# **PRELIMINARY/FINAL DRAINAGE REPORT FOR JUDGE ORR RANCHETTES**

October, 2017

PCD FILE NO's: SP-17-011  
SF-17-021

Basin ID: DP-P3

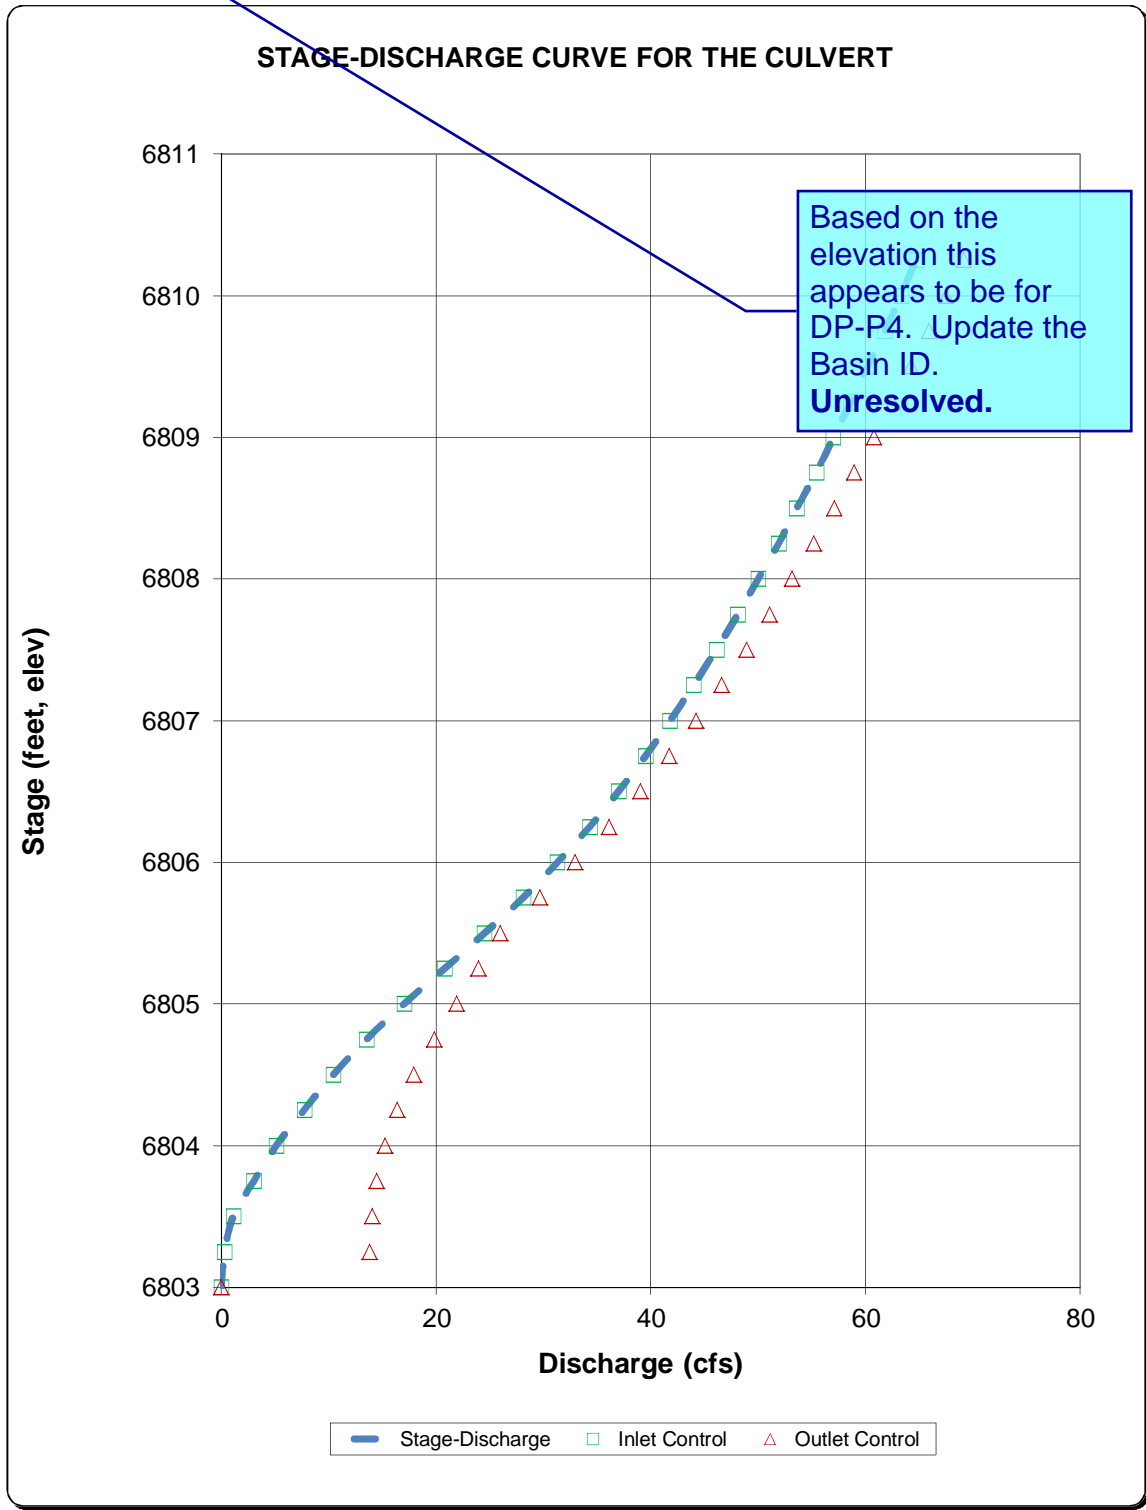
The outlet protection worksheet is missing.

Culvert Calculation for Design Point P3 is missing.

Label is missing. "Design Point P4)
